Replacement of BPD1265 (WVA 24529) with BPD1548 (WVA 25087).

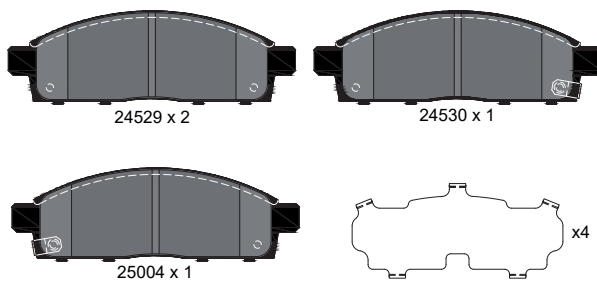
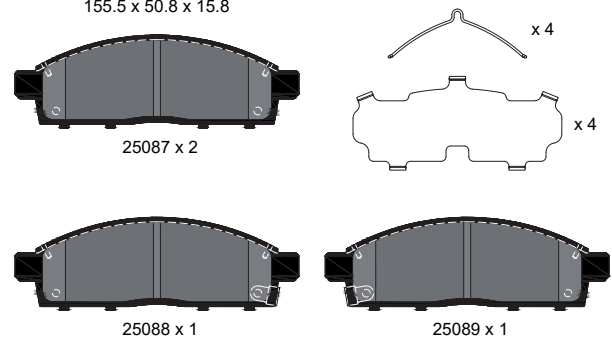
Bendix aims to streamline the designation from BPD1265 to BPD1548.

Given the identical nature of the brake pads we can ensure seamless assembly and operation.

This consolidation extends coverage to a broader range of vehicles under a singular reference, namely BPD1548 which comes with drill holes in the plate and therefore is able to cover applications of both part numbers.

BPD1265

155.5 x 50.5 x 16.0

**BPD1548**

155.5 x 50.8 x 15.8

The current inventory of BPD1265 can be effortlessly marketed and sold without any complications.
